DA20/0016 – Electricity Generating Works (PV solar farm) – 157 Windmill Lane, Bomen**Request for clarification following Regional Planning Panel site visit**

Figure 1 – Comparative reflection of PV solar panels and other materials

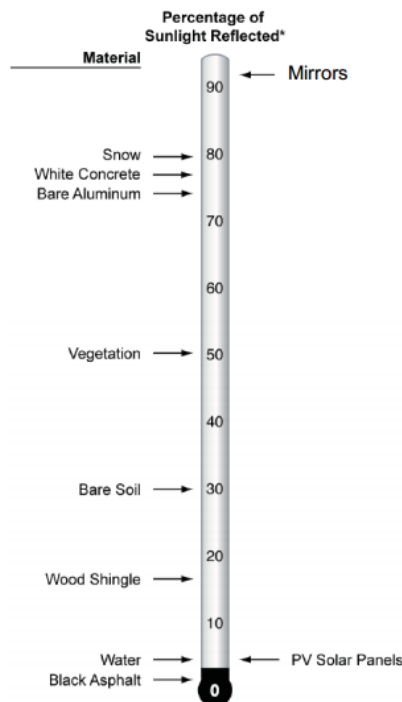
There is concern that the impacts are presented as nil when the recently constructed Bomen solar farm is causing glare impacts to nearby properties.

Is there any opportunity to provide comments (prior to the meeting) in response to the 'nil' impacts presented in the IRIS report and how the site is comparable or not comparable to the Bomen solar farm. As discussed this might be that glare impacts are experienced from (x,y,z) but no sensitive receptors will experience glare.

The percentage of sunlight reflected by PV solar panels is similar to that of water and less than most other surrounding materials, as illustrated in **Figure 1** below. The low reflectivity design of the PV modules maximises the absorption of solar energy and therefore minimises the extent of solar energy reflected.
